**Hearing Identifier:** Seabrook\_LA\_NonPublic  
**Email Number:** 429

# **Talking Points for Audit Questions**

**June 2017**

## 100-40-40, Question 1

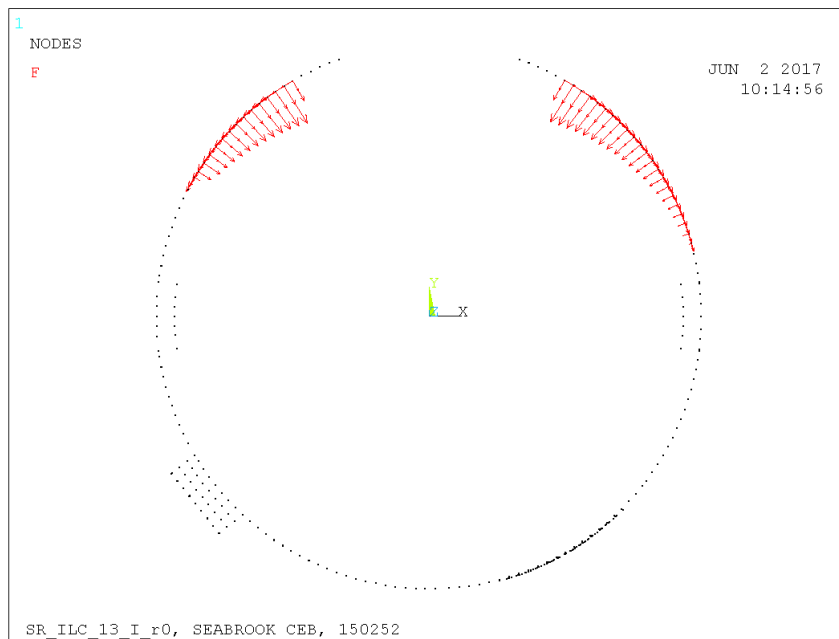
***Describe how the dynamic soil pressure load ( $H_e$ ) was calculated and applied to the structure.***

***NRC noted that “The magnitudes in the two opposite seismic directions are significantly different in some cases”...***

- Dynamic soil pressures are calculated based on SD-66 Section 8.2.
- Dynamic soil pressures are combined consistently with seismic inertial loading using 100-40-40.

- Dynamic soil pressures are not symmetrical for north/south direction of loading due to presence of soil and penetrations.
- Responses are local and direction-dependent. Reversing the direction of load does not necessarily invert the response.

## **ASR Load Factors, Question 3**

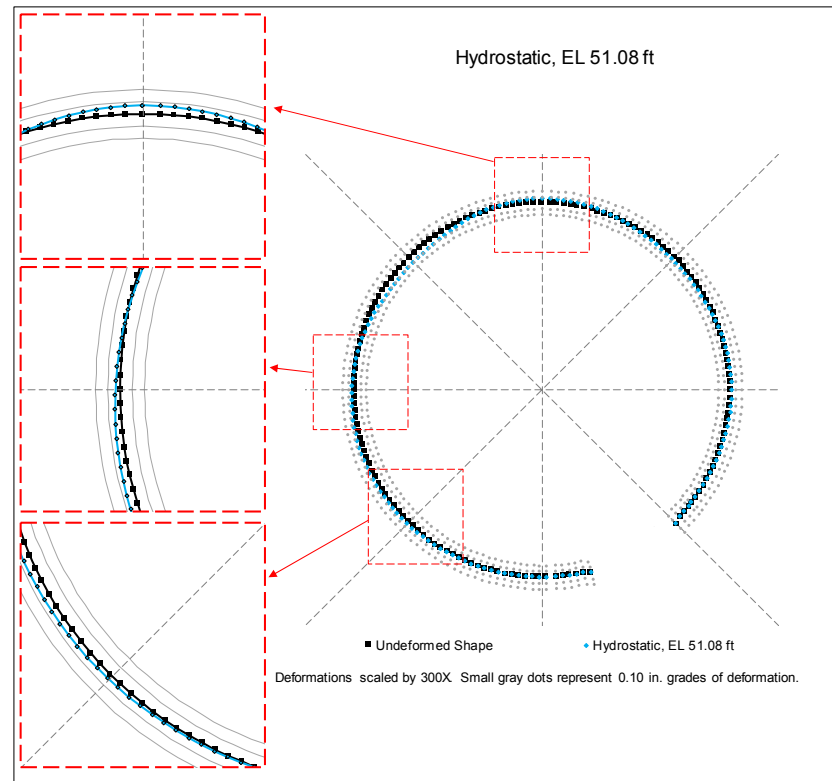
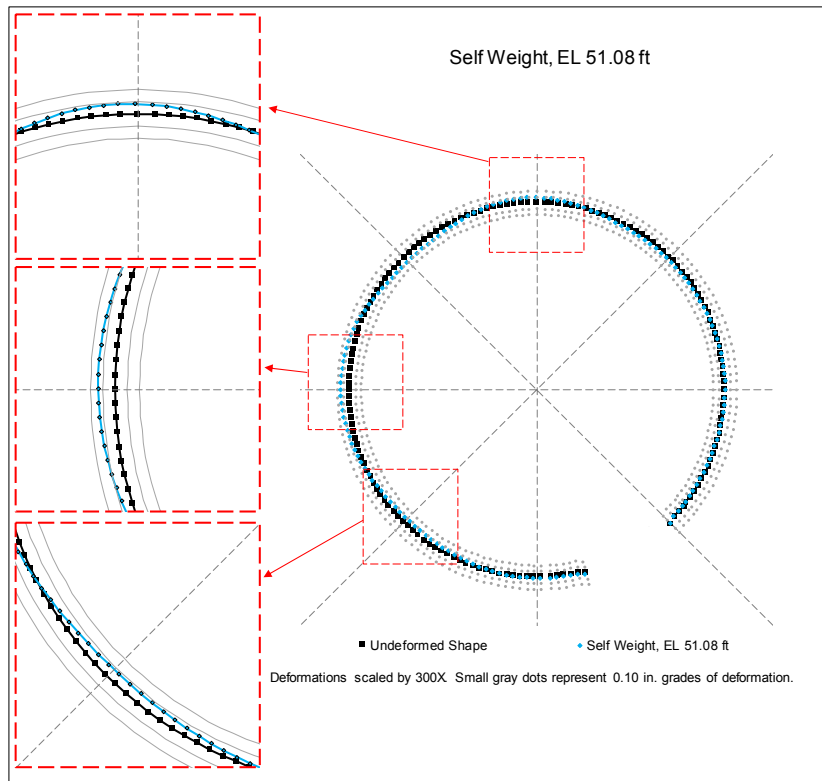
***The NRC hand calculation suggests lower ASR deformation than indicated by CEB calculation.***

***What is the difference between the displacement calculated in the ANSYS ASR-only analysis and the displacement calculated in the ANSYS unfactored static load combination analysis?***

- The large penetrations in the CEB causes ASR deformations to be larger than the suggested hand computation. While the effects of the penetrations reduce as you move higher up on the CEB, they do not go away completely.

- Plots of deformed shape provide a more comprehensive understanding on the CEB behavior.
- Deformation contributions of individual load cases are tabulated for select locations.
